ARCHITECTURAL REVIEW COMMISSION AGENDA

May 30, 2019

To: CH Architectural Review Commission (ARC)
From: Matt Taylor, Senior Planner
Date: May 30, 2019
Subject: Canyons Veterinary Clinic: Project SPL-19-006

To: Architectural Review Commission
From: Andy Hulka, Associate Planner
Date: May 30, 2019
Subject: SPL-19-003 – 6890 S. Highland Dr. – KFC

Side Elevation (South, Drive-Thru)
Existing

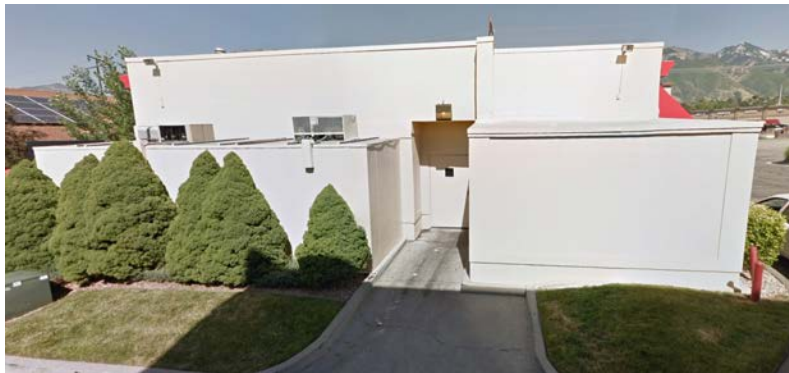
The south side has also been revised to include new exterior light fixtures that do not extend above the roof and a red/white paint color scheme.

Rear Elevation (West)

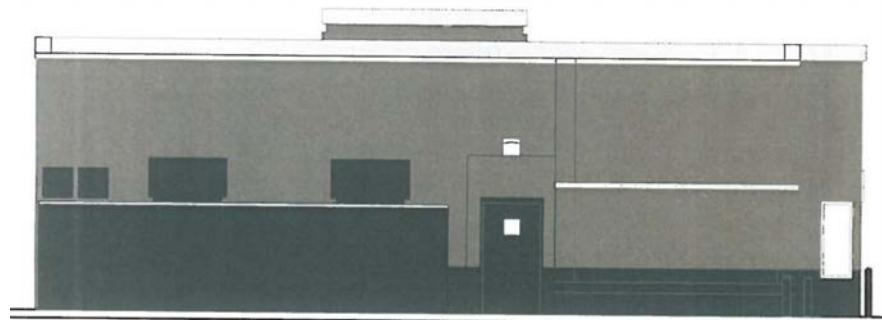
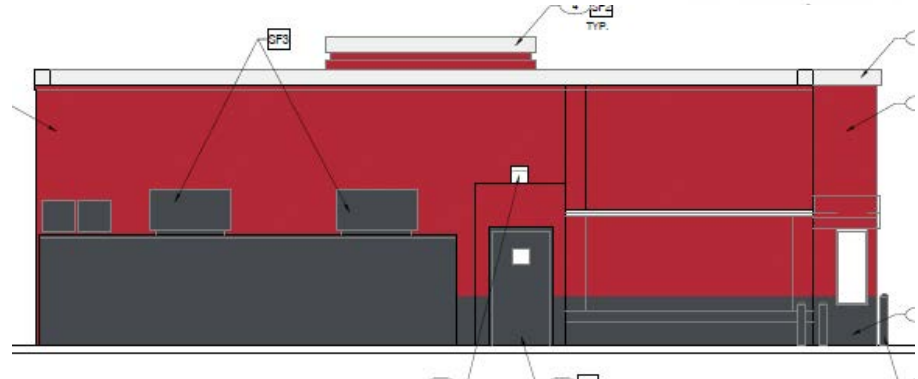
The west wall is now proposed to be painted almost entirely red.
